**RESPONSE TO ENVIRONMENTAL PROTECTION  
AGENCY'S INFORMATION REQUEST FOR  
NPDES PERMIT RE-ISSUANCE**

**PSNH SCHILLER STATION  
PORTSMOUTH, NEW HAMPSHIRE**

**Prepared for  
Public Service Company of New Hampshire**

Enercon Services, Inc.  
500 TownPark Lane  
Kennesaw, GA 30144  
August 2013

Figure 1: Illustration of Dual Flow Screen [Ref. 9.11]

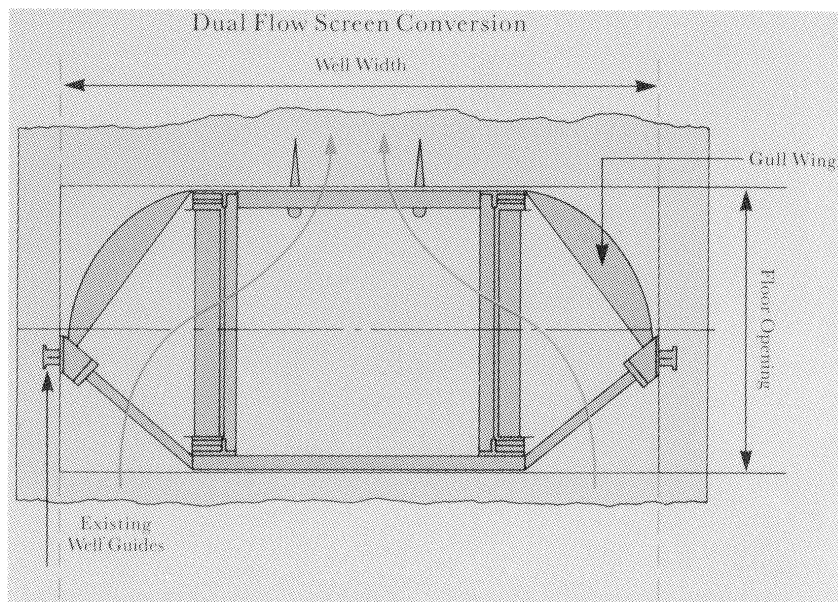
*EPA also requests additional information about the feasibility of dual flow screens at Schiller Station. PSNH determined that dual flow screens were technologically infeasible because the size of the existing intake structure could not accommodate a dual flow retrofit. PSNH also indicated that total replacement or extensive modifications of the intake structures would be required at a cost much higher than the cost of the screens themselves. Please provide further explanation or supporting information to document or explain these assessments.*

As discussed above in Section 8.2, the through screen velocity is reduced in a dual flow screen because of the increased screening area. However, dual flow screens create higher flow velocities as the flow approaches the screen. Because of the plate and gull wings that are installed to divert the flow to either side of the dual flow screen, there is less flow area in the region after the flow splits. This creates higher approach velocities as the flow passes around the plate and turns in towards the screening surface. Note that the plate is necessary to prevent unscreened flow from passing through the middle of the screen, and the gull wings are necessary to direct the flow towards the screening surface.

These components cause the approach velocity (defined here as the flow velocity just before the flow enters the screen) to be considerably higher than the through screen velocity. For a through flow screen, the approach velocity is typically slightly less than the through screen velocity due to the reduction in open area within the screen, and lack of other flow restrictions in front of the screen such as a plate. In the budgetary proposal, EIMCO stated that the through screen velocity for the dual flow screen would be 0.5 feet per second, but also that the velocity through the side entrance openings would be 1.27 feet per second [Ref. 9.9].

Installation of dual flow screens would reduce the through screen velocity to 0.5 feet per second, as noted above in the EIMCO proposal. Per EPA's statement in Reference 9.7, most fish would be able to swim away from the screen. However, the approach velocity around the plate and through the side entrance openings would be 1.27 feet per second [Ref. 9.9]. This exceeds the 0.5 feet per second criterion stated by EPA above, and could prevent some fish from swimming away [Ref. 9.7]. Therefore, fish entering into the region between the plate and screens might not be able to swim away and could become trapped and possibly impinged.

To reduce this velocity, the available space on either side of the wall plate would need to be increased. For Screen House #2, which was used as input to EIMCO, the intake channel width is 6' – 8" [Ref. 9.8]. Because the overall dual flow screen breadth would be 3' – 11" [Ref. 9.9], clearances of approximately 1' – 4 ½" remain on either side of the plate through which flow can pass. In order to reduce the side entrance velocity from 1.27 feet per second to 0.5 feet per second, this gap would need to be increased from 1' – 4 ½" to approximately 3' – 6" on either side. If this were to be achieved by widening the intake channel, the channel would need to be widened from 6' – 8" to approximately 10' – 11", an increase of 4' – 3" in width. From drawings of this Screen House [Ref. 9.10], the thickness of concrete separating each of the intake channels at water elevation ranges from 3 – 4 feet. Expanding the intake channel to achieve a side entrance velocity of 0.5 feet per second around the dual flow screens requires more space than is available and therefore is not feasible. Expanding the depth of the intake channel to achieve this velocity is also infeasible, given that the depth would have to increase by a factor of approximately 2.5.
